To: **Sunshine Coast Regional District** Date: **January 24, 2024**
Attention: **Drew Brennan** Project No.: **33642**
Cc:
Reference: **Chaster Park Pedestrian Bridge and Revetement Wall Planning Options**
Cliff Gilker Park Bridges and Trail Recovery Options – REVISED MAY 22, 2024
From: **Richard Avedon-Savage and Janet Tong**

To: **Sunshine Coast Regional District**Date: **April 3, 2024**Attention: **Drew Brennan**Project No.: **33642**

The Sunshine Coast Regional District (SCRD) submitted questions to ISL regarding the report and memo on the conceptual options study for a new pedestrian bridge at Chaster House and condition inspection of the revetment wall at Chaster House Park,

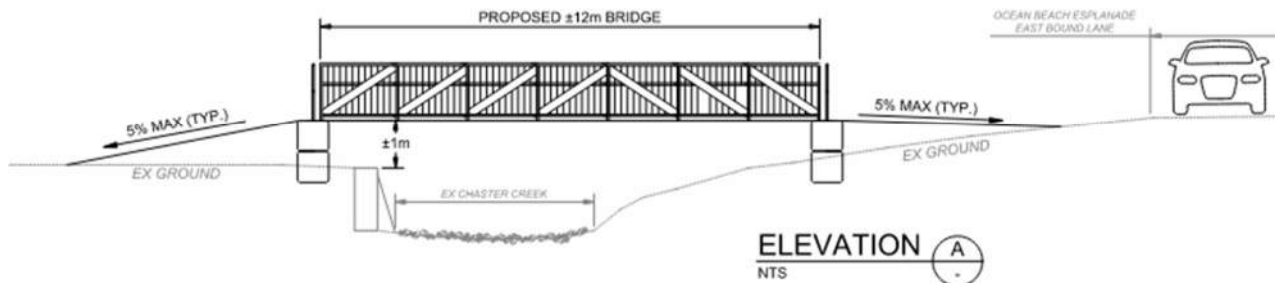
Q1b. Is there a likely chance that the abutments could be impacted due to land sloughing or unexpected movement/ stability due to the saturation of ground in this location for approximately 6 months of the year?

A1b. Detailed design would include review and recommendations for foundation settlement. It is anticipated however, that new spread footings would be founded with sufficient depth to be founded on well-graded and free-draining material. If a geotechnical investigation finds that there are poor foundation soils then the bridge may be founded on steel piles which would be less affected by the surrounding ground.
